**2201CADD0 - Addendum No. 1
To Plans, Contract Documents and Specifications**

**Caddo Mills Municipal Airport
Apron Reconstruction and Runway Remarketing
TxDOT CSJ No. 2201CADD0**

SHEET INDEX & SUMMARY OF QUANTITIES

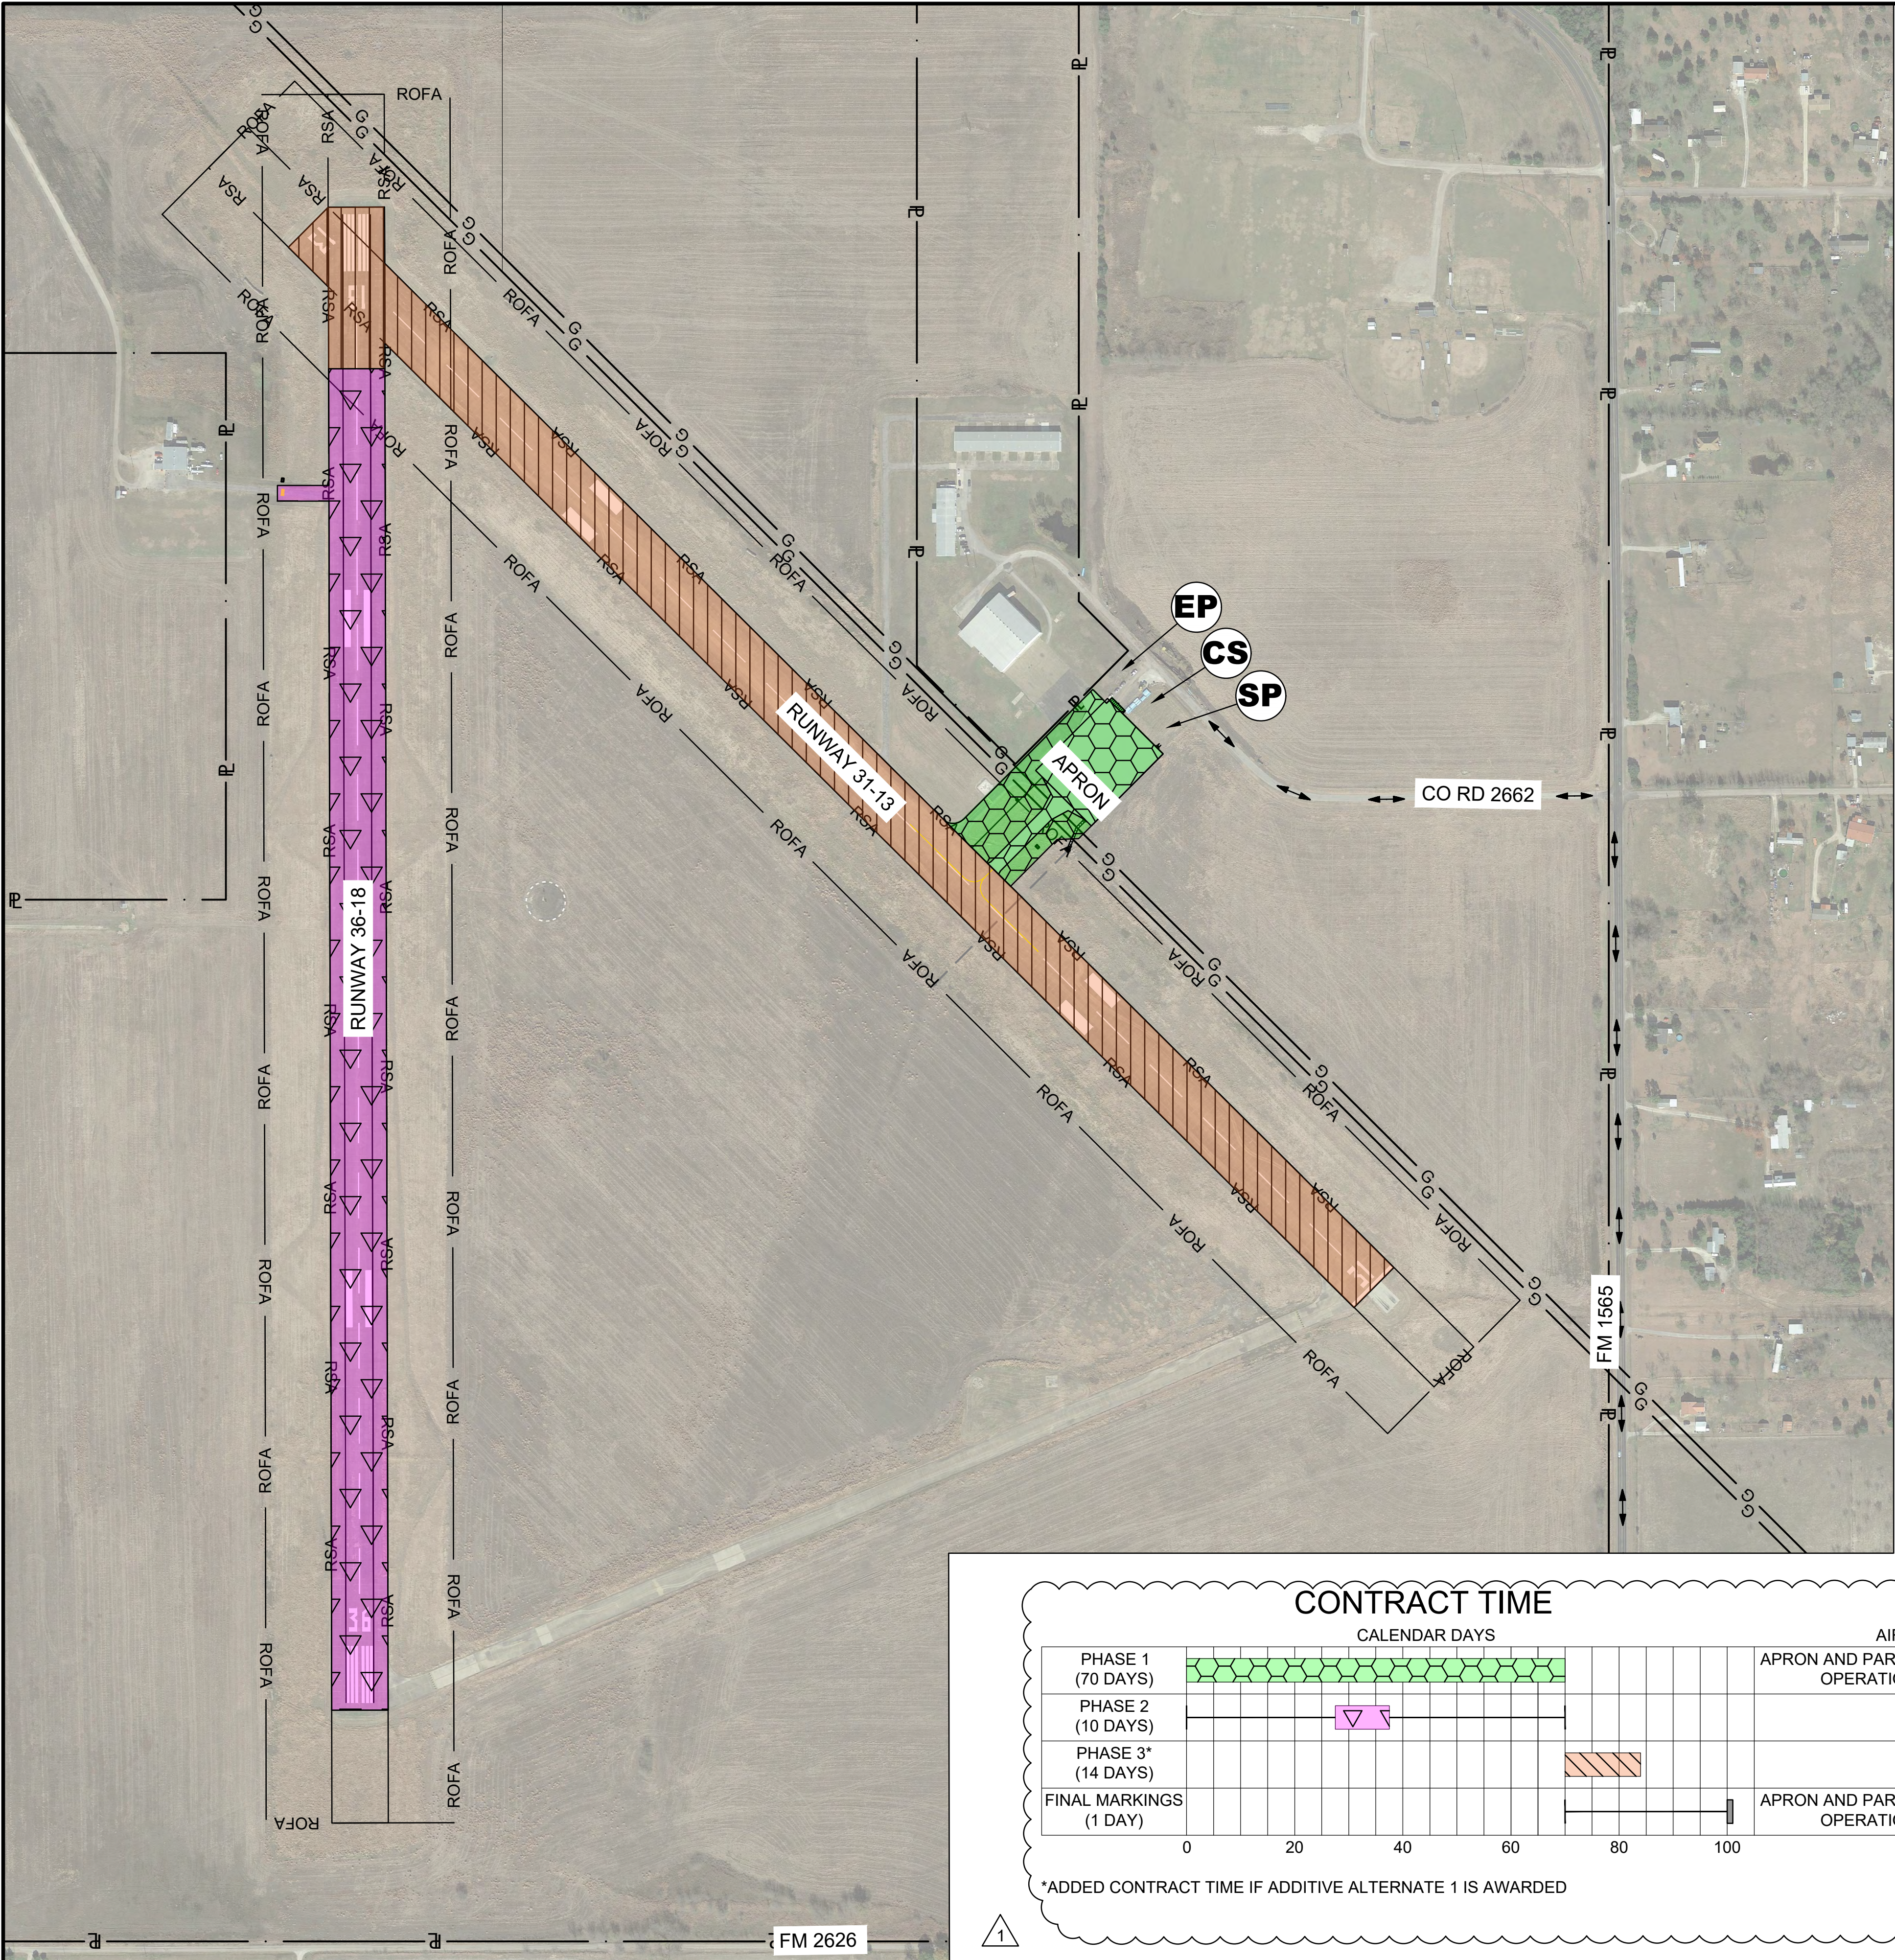
Sheet GI-002 was revised to remove the Summary of Quantities tables.
Sheet GC-003 the contract time, sequence of construction, and legend was revised.
Sheet CG-101 the contract time, sequence of construction, and legend was revised.
Sheet GC-102 the page number, contract time, sequence of construction, and legend was revised.
Sheet GC-103 the page number, contract time, sequence of construction, and legend was revised.
Sheet CE-101 the legend was revised.
Sheet CP-002 Detail 7 was revised.

FOR ALL QUANTITIES
REFER TO THE REVISED TxDOT FORM 2506 WITHIN ADDENDUM NO. 1

CSPP - PHASE 3

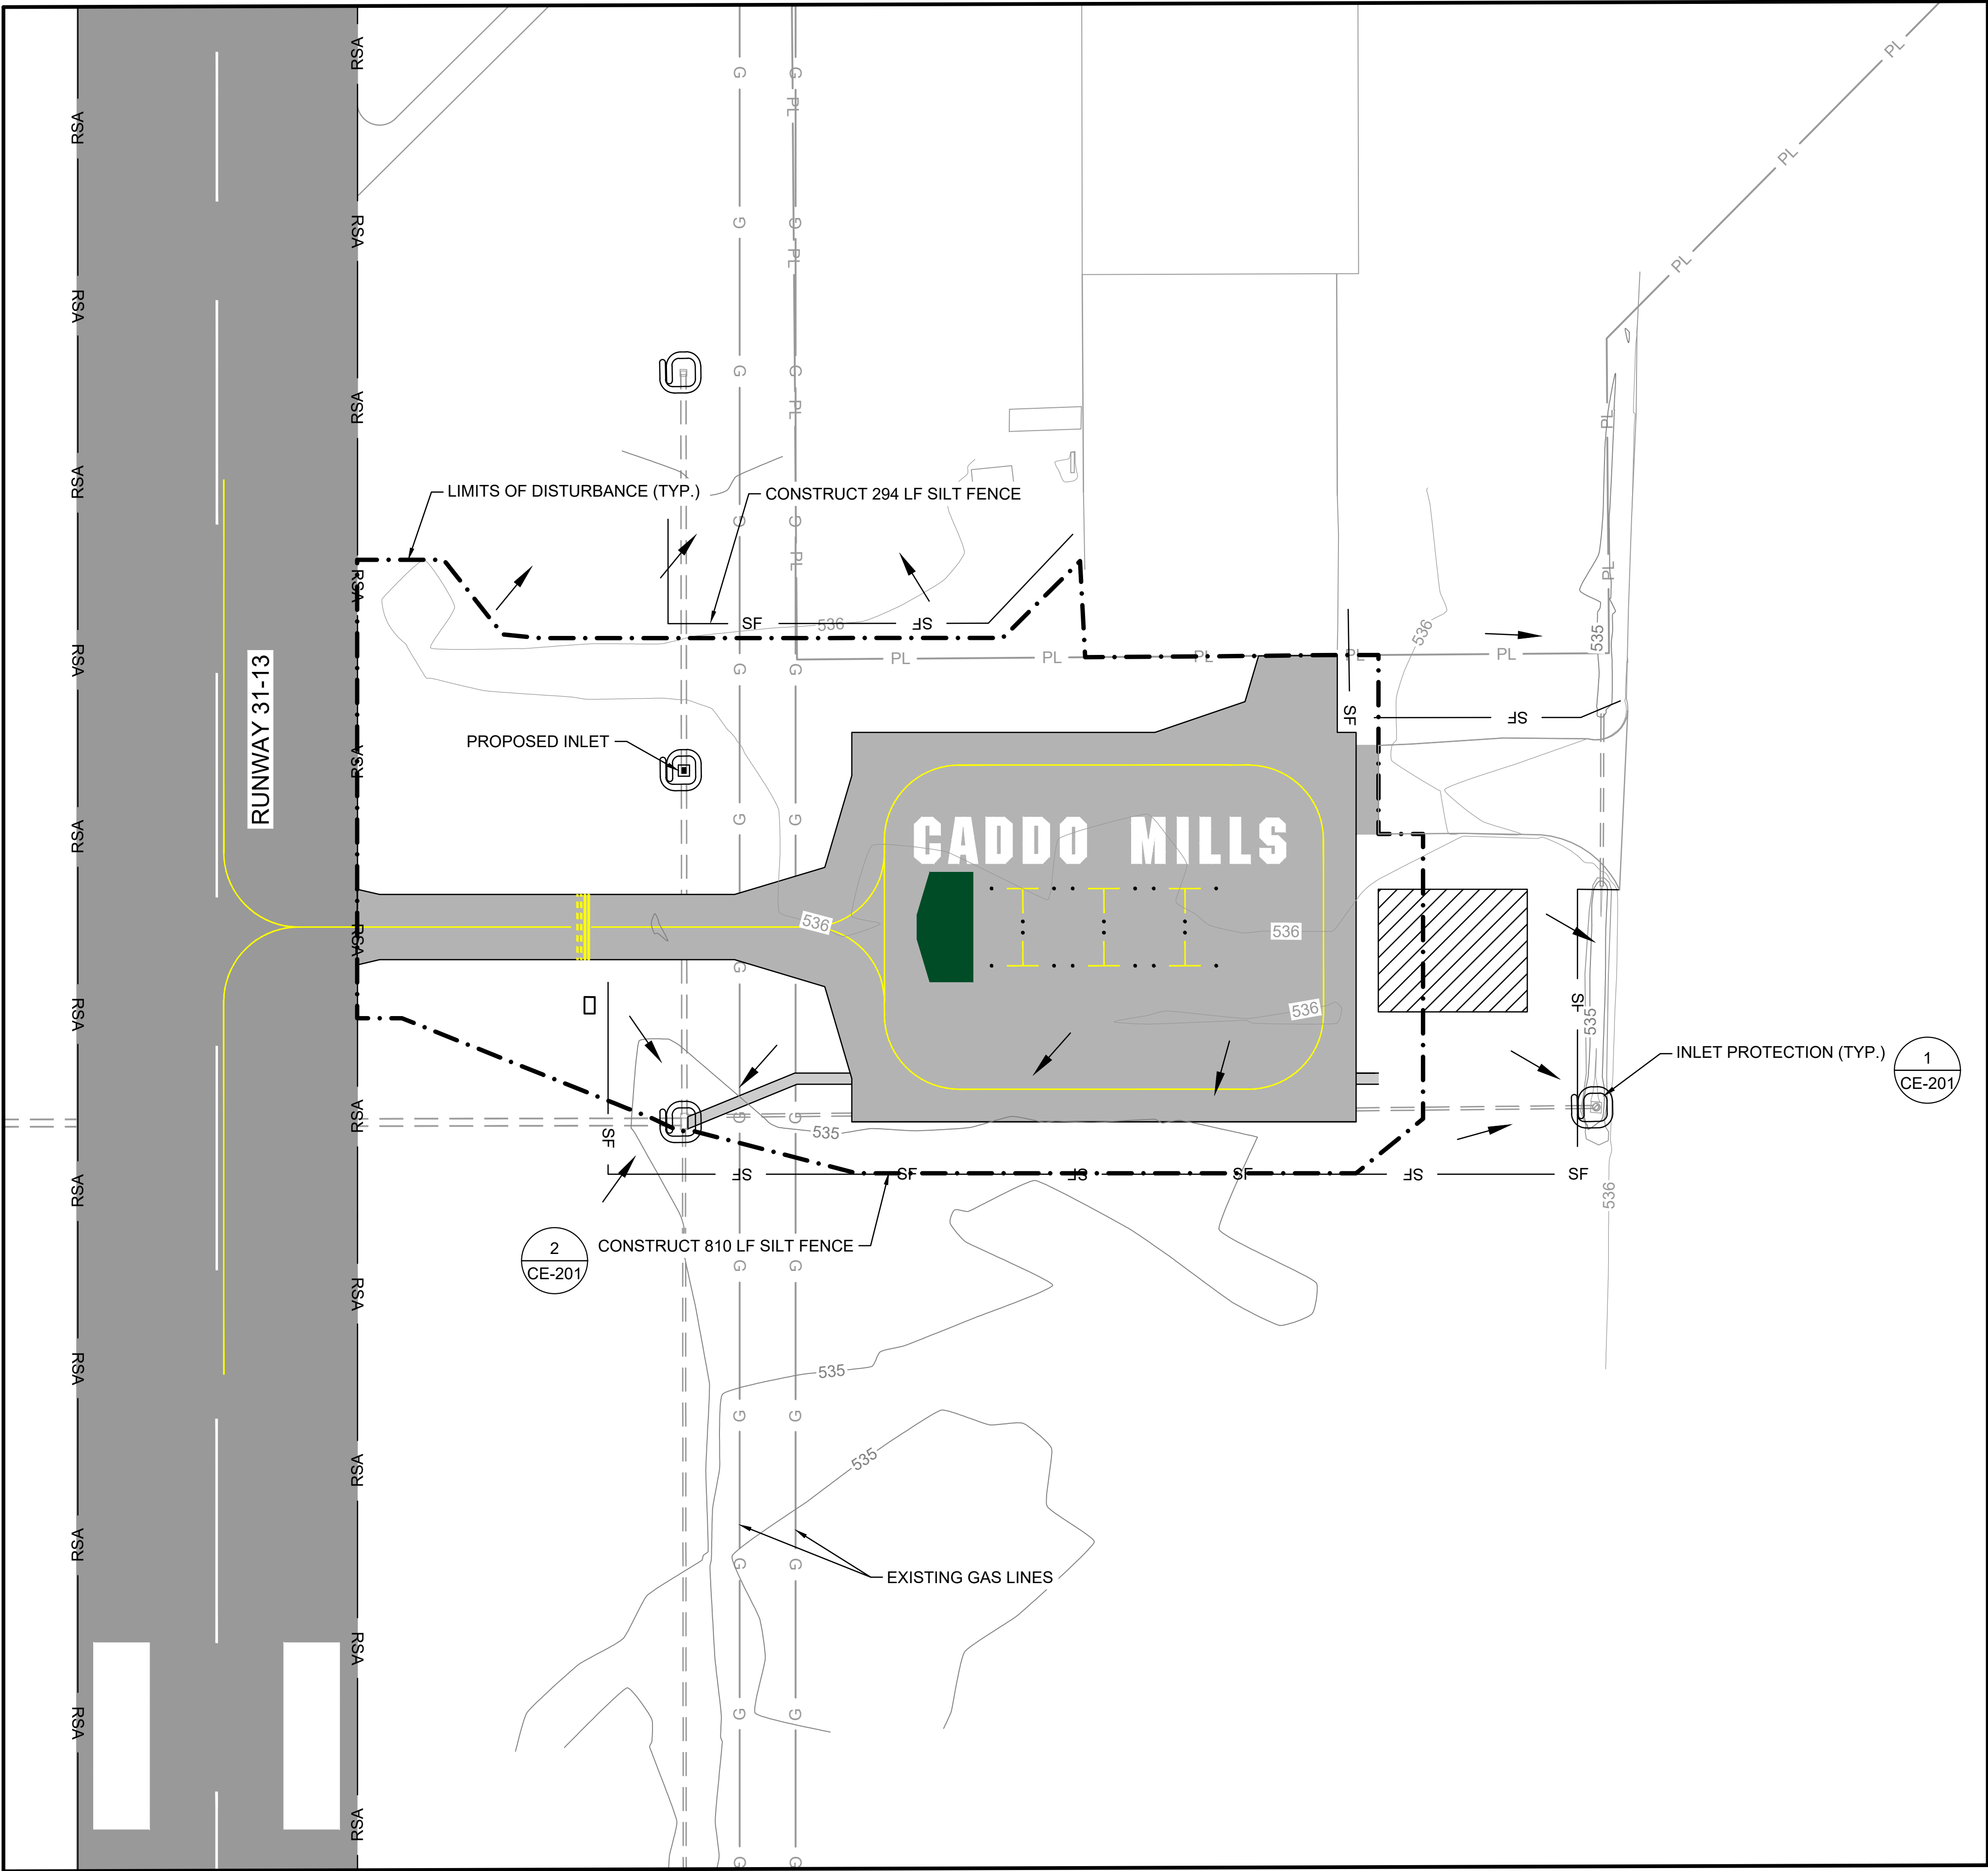
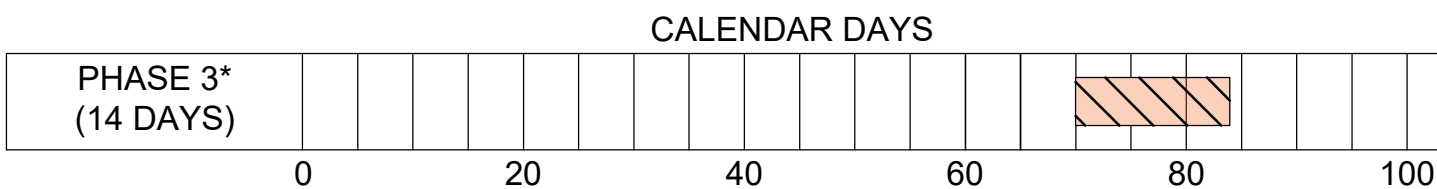
Revised Plan Sheet: GC-102 – CSPP Phase 2
Revised Plan Sheet: GC-103 – CSPP Phase 3
Revised Plan Sheet: CP-002 – Typical Sections & Details II
Revised Specification: SS-262 Tiedown Anchors
Revised Specification: TX-247 Flexible Base
Revised TxDOT Bid Form 2506 for 2201CADD0

- 3 REMOVE AND REMARK PAVEMENT MARKINGS ON RUNWAY 31-13 FROM THE RUNWAY 13 THRESHOLD UP THROUGH THE THE INTERSECTION OF RUNWAY 36-18.

RW 31-13 PAVEMENT REMARKING TO FOLLOW APRON CONSTRUCTION
